Saint Ignatius' College - s4.55 Modification to SSD 7140

JULY 2020

Saint Ignatius' College
RIVERVIEW

Proposed Modifications

REVISED MASTERPLAN PRECINCT DEVELOPMENTS

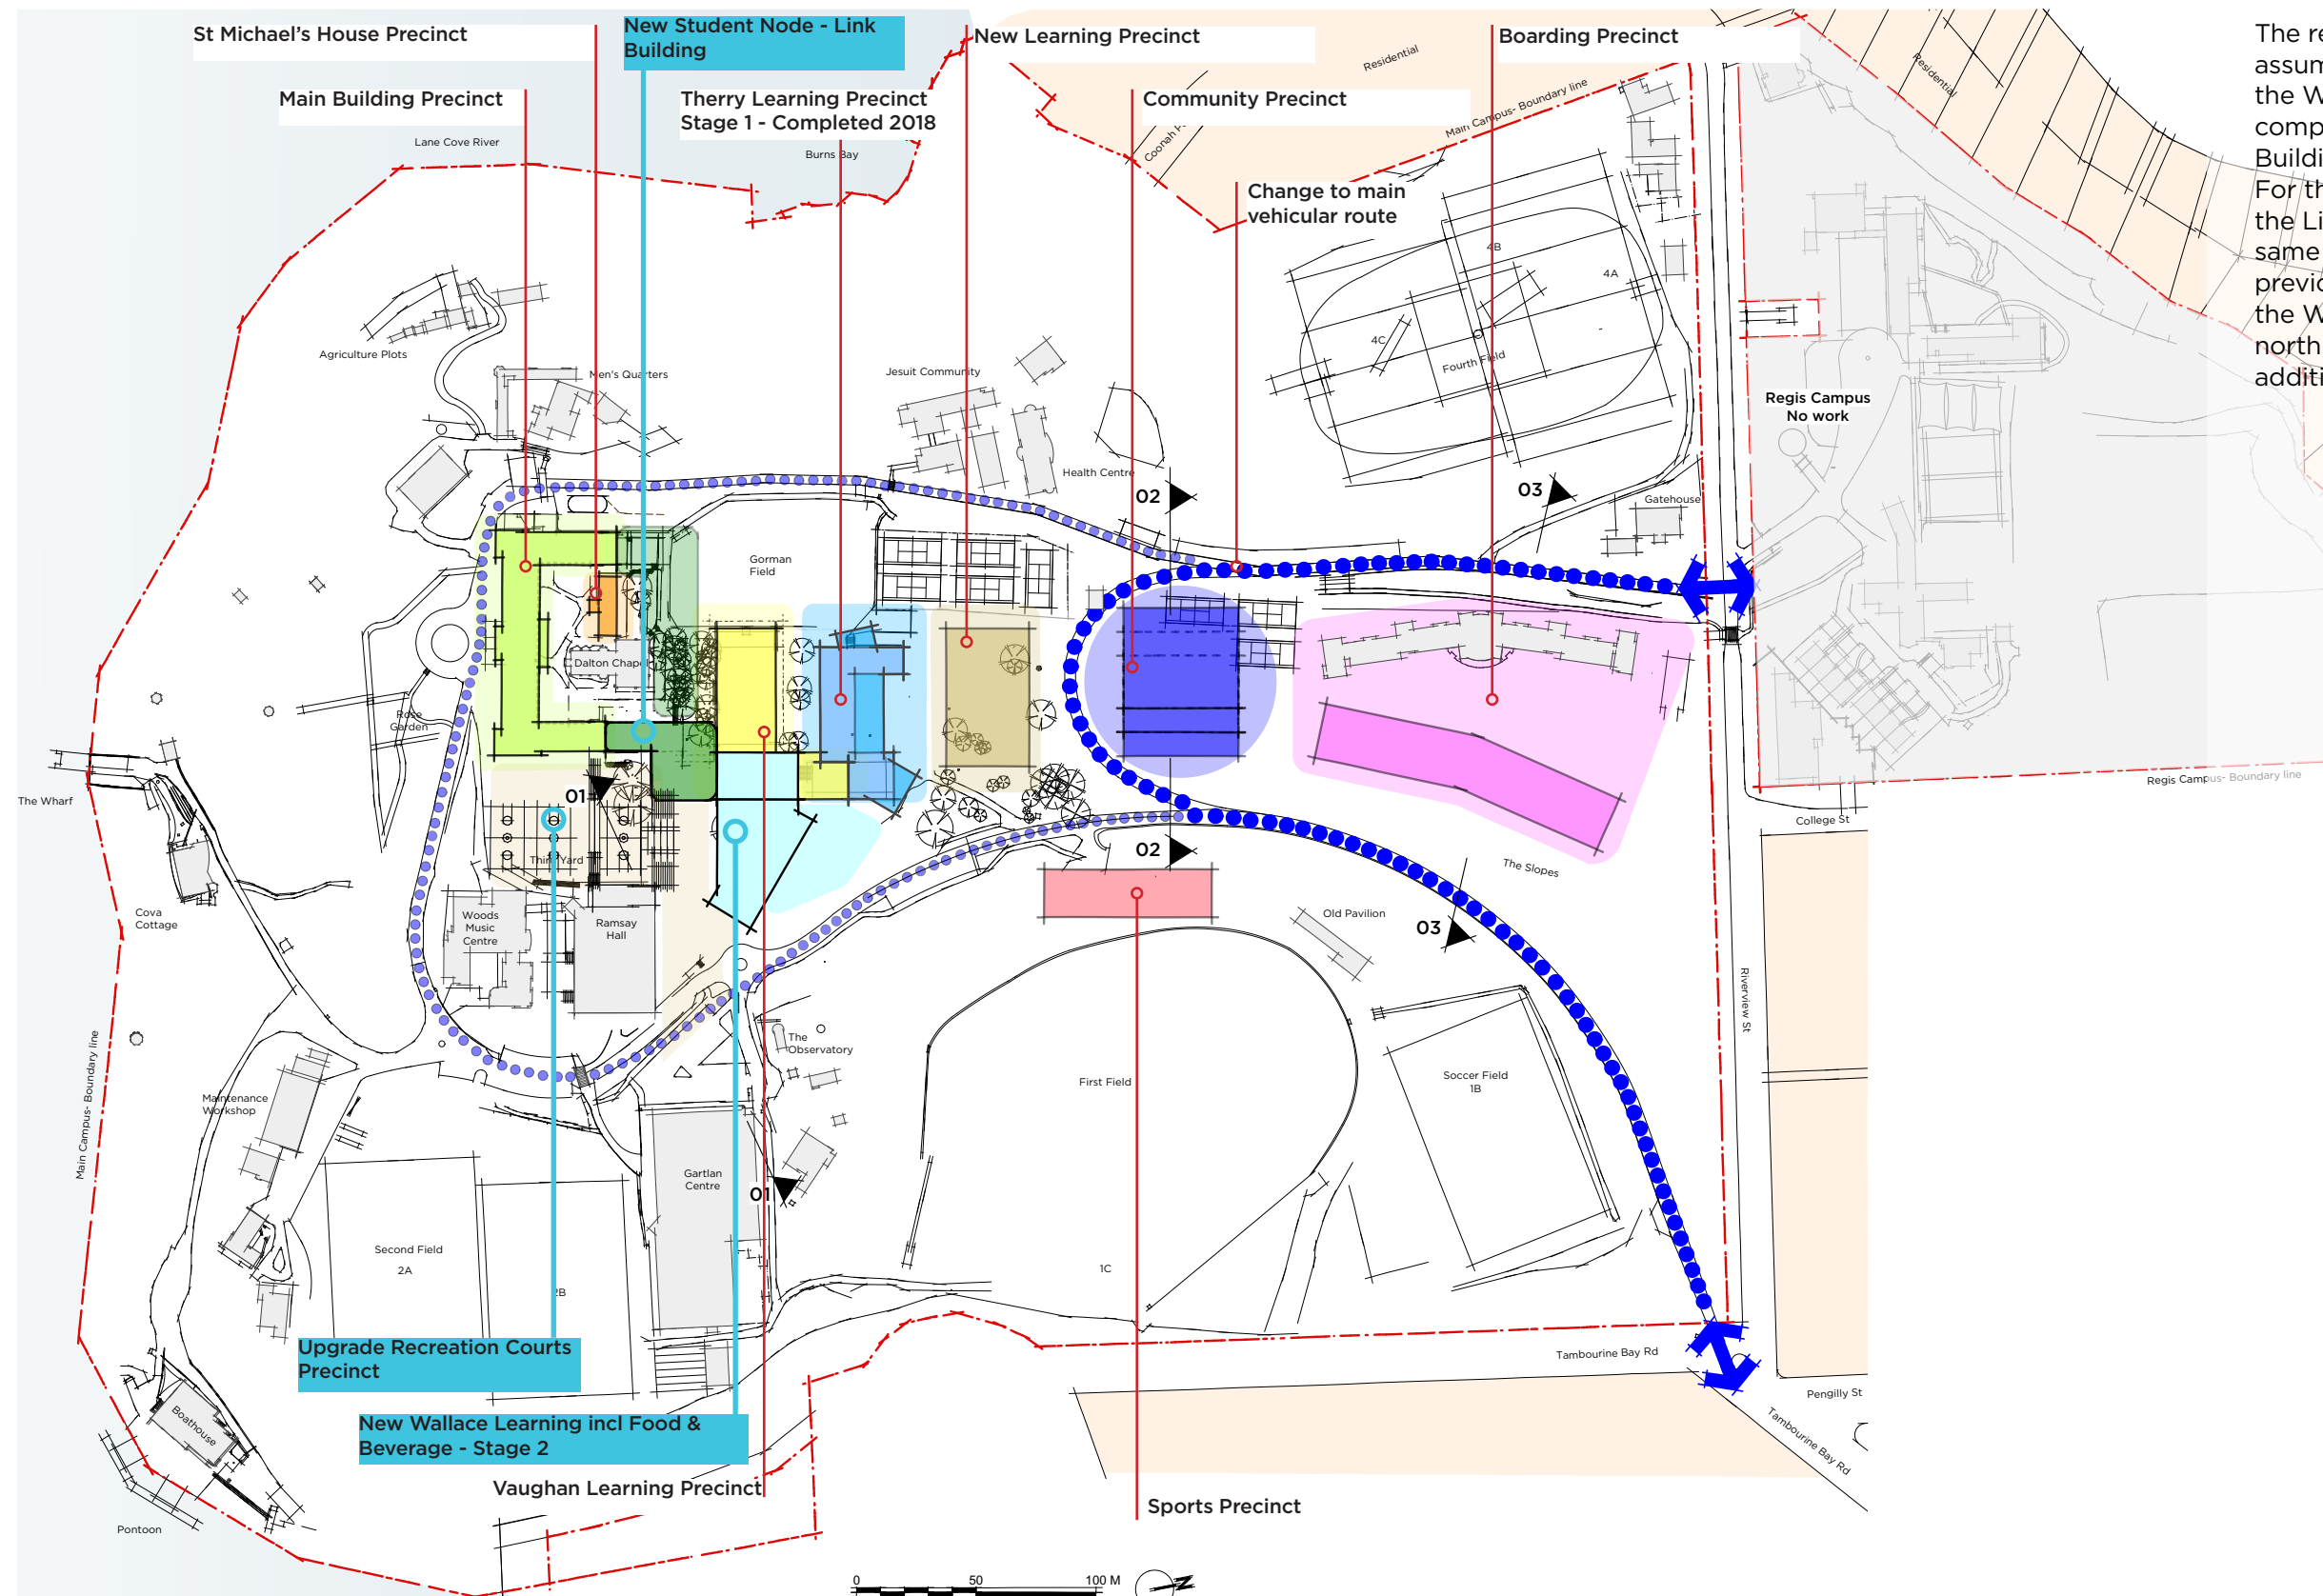
The revised precinct proposals assume the same break up of the Wallace Precinct into two components being the Link Building and the Wallace Building. For the modification it assumes the Link Building remains the same in height and areas as previously shown and that the Wallace Building is shifted north with greater footprint and additional area.

REVISED STAGES | NEW STUDENT NODE - LINK BUILDING

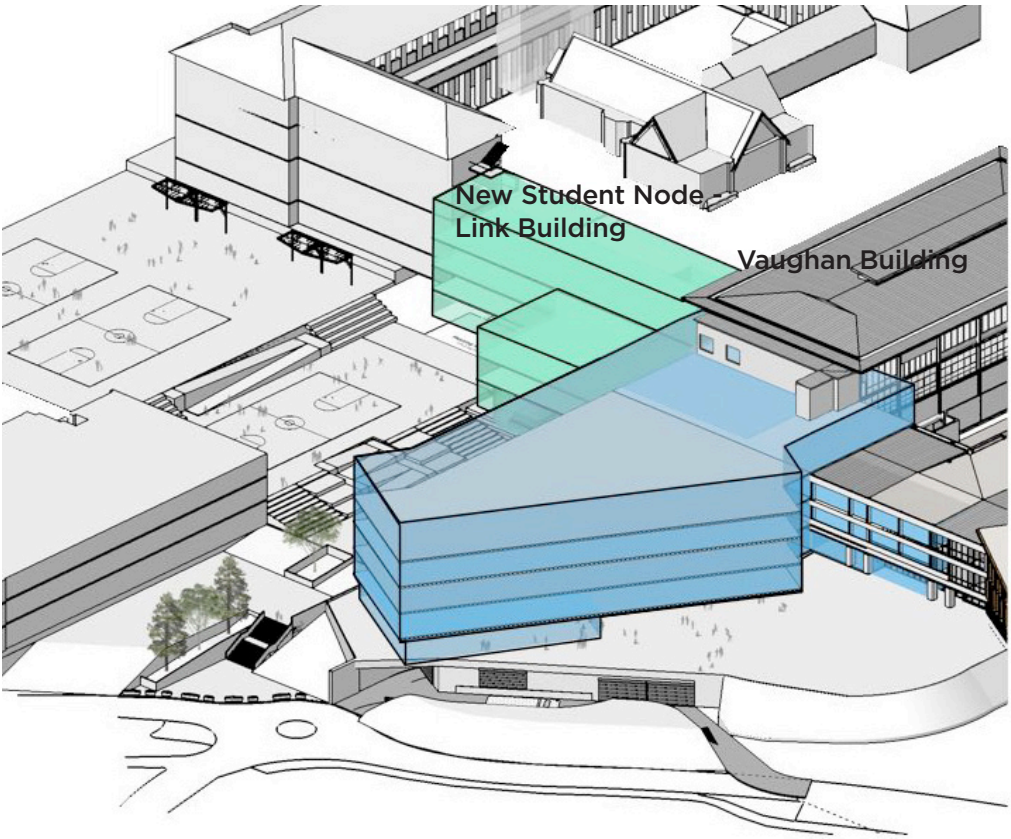
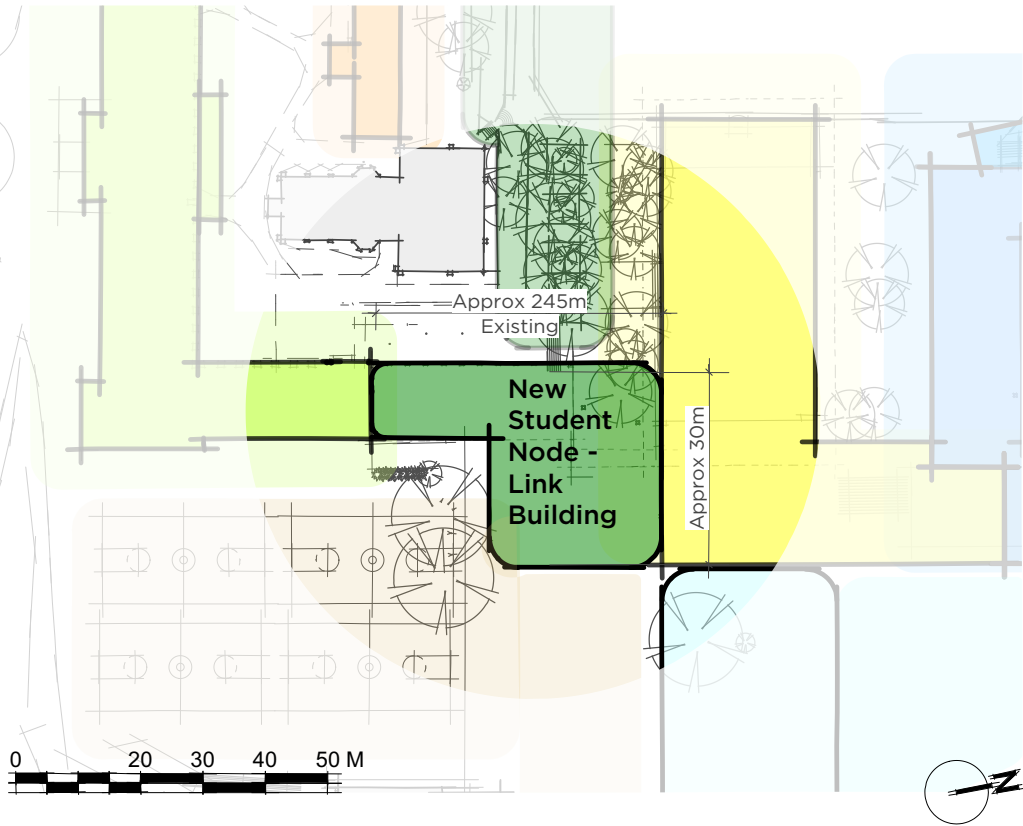
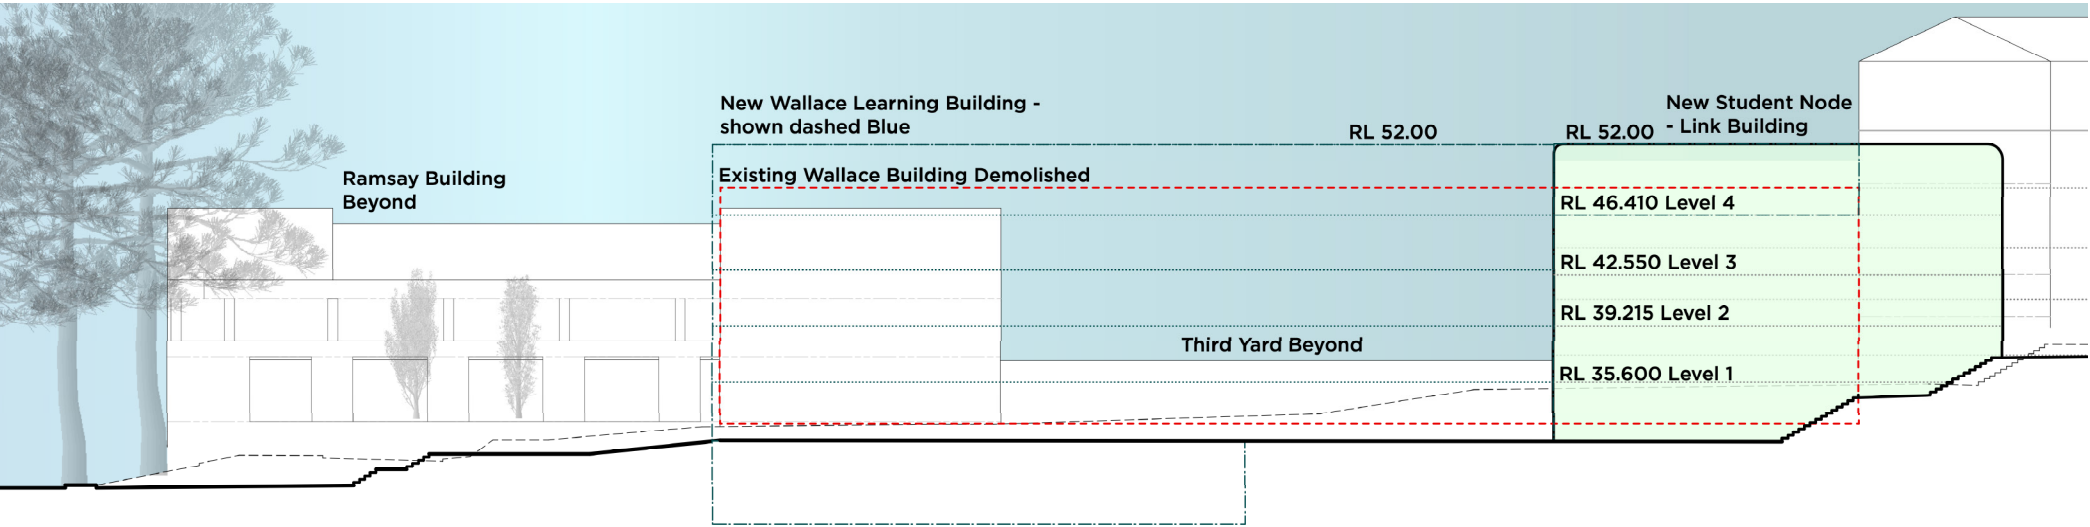
- New Student Node - Link building**
- GFA = 3,800m² (same area previously approved)
 - Number of Levels = 5
 - Building height = RL 52.00 ((1.0m higher than previously approved)

Demolish the existing Administration building and replace with new facility of greater footprint in same location between existing Main & Vaughan buildings. Height of new building at 5 levels the same as approved scheme. The new building provides a centralised location for student and staff support services and an arrival point to the Learning Precinct.

REVISED STAGES | NEW WALLACE LEARNING BUILDING

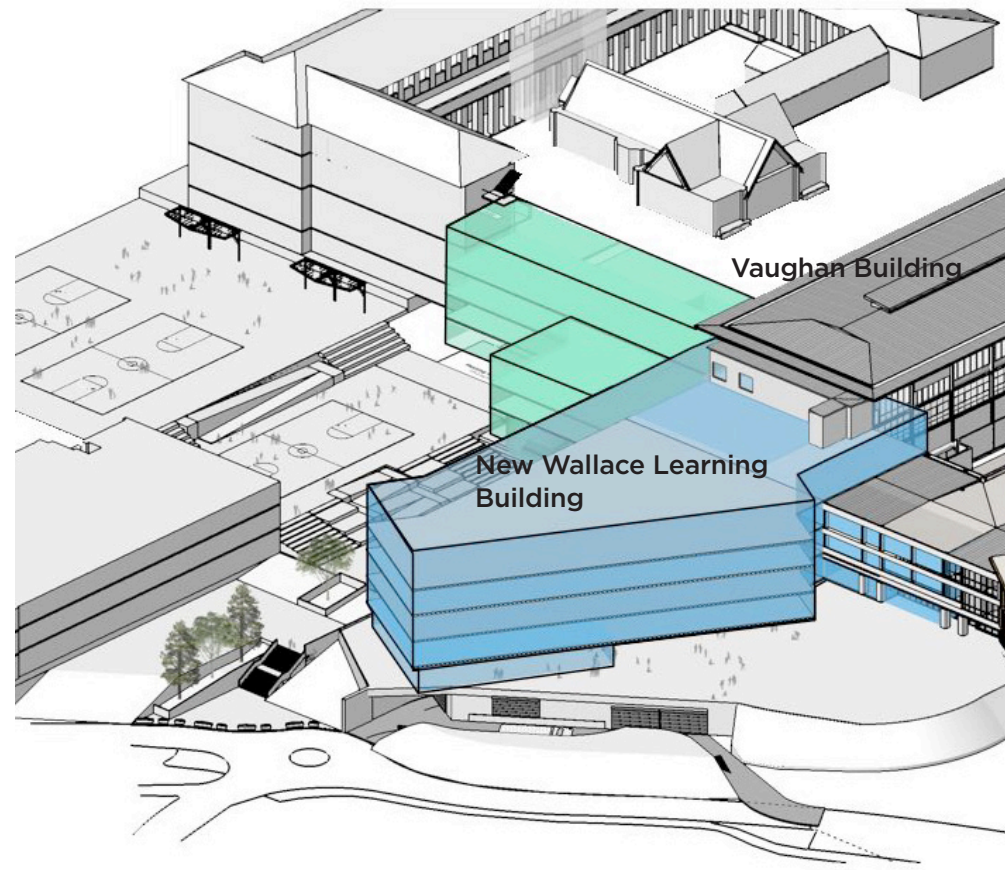
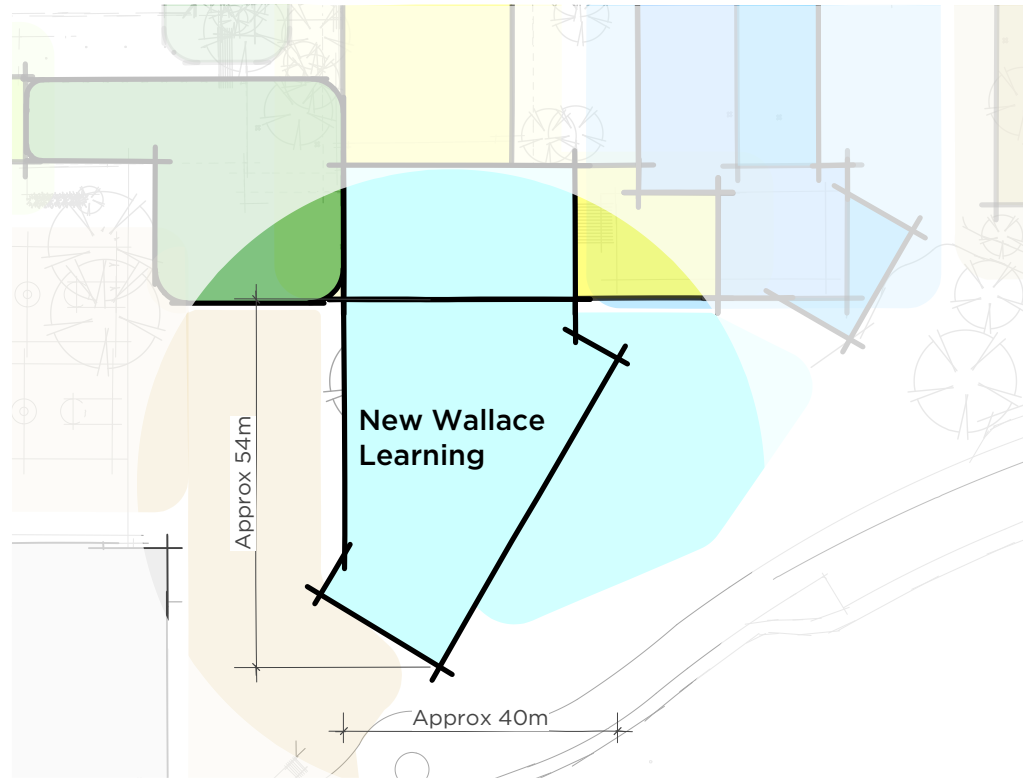
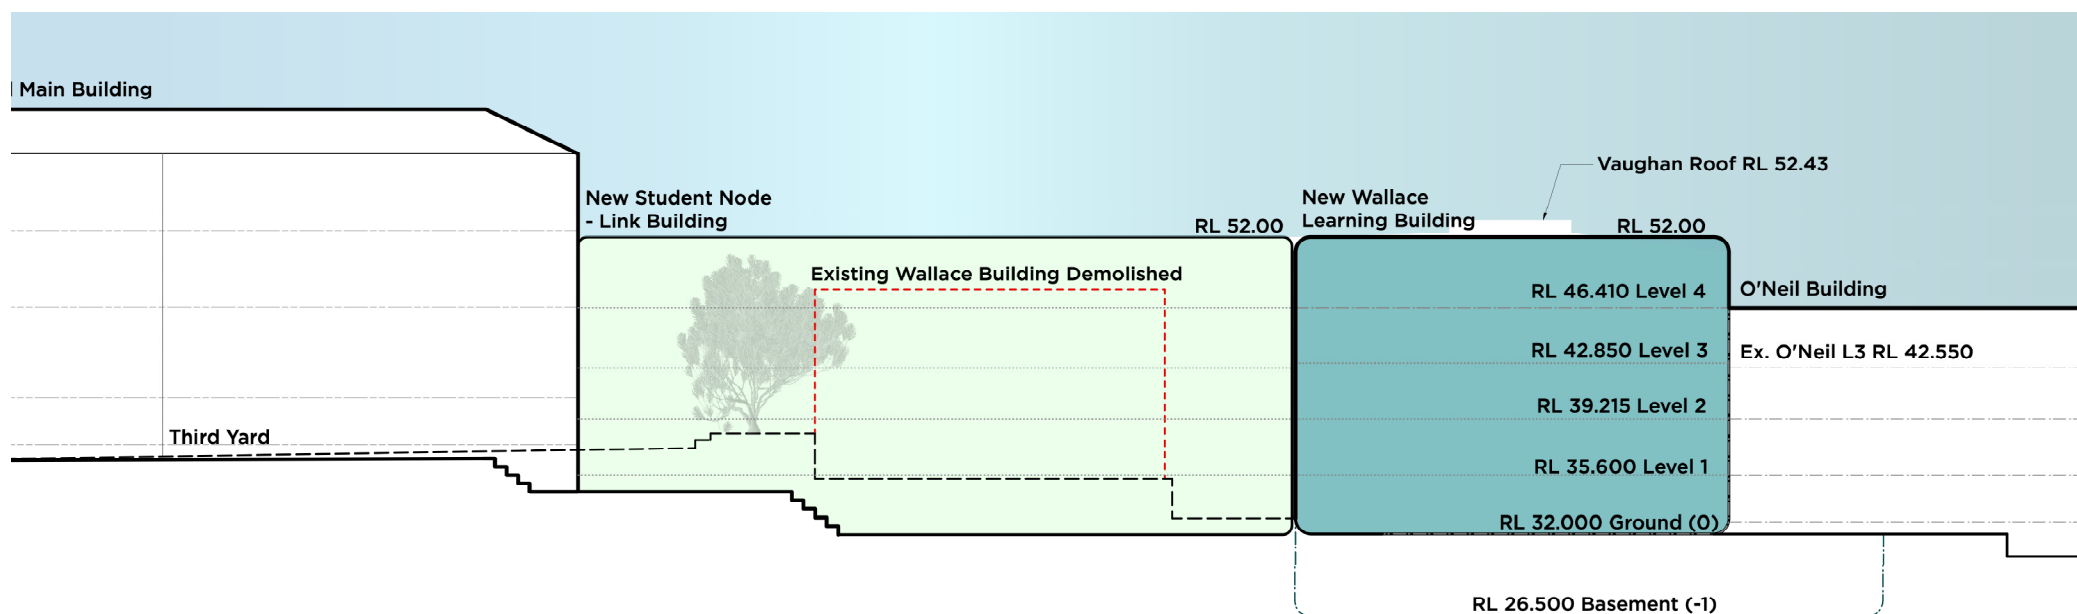
- GFA = 6,175m² (Additional 2,515m² than previously approved)
- Basement of 1,000m² not included in GFA
- Number of Levels = 5
- Top of Building = RL 52.00 (1.0m higher than previously approved)

Demolish the existing Wallace and replace with new facility of greater footprint located 30m north attached to existing Vaughan building. Height of new building at 5 levels will be 1 level higher than the approved scheme which will equate to the existing top floor level of the existing Vaughan Building. The new building will provide improved and diverse learning opportunities for Science, Technology, Engineering, Mathematics and PDHPE as a STEMP facility. Ground level will accommodate a C.O.L.A and Canteen (Food & Beverage) with servicing by loading area on basement level.
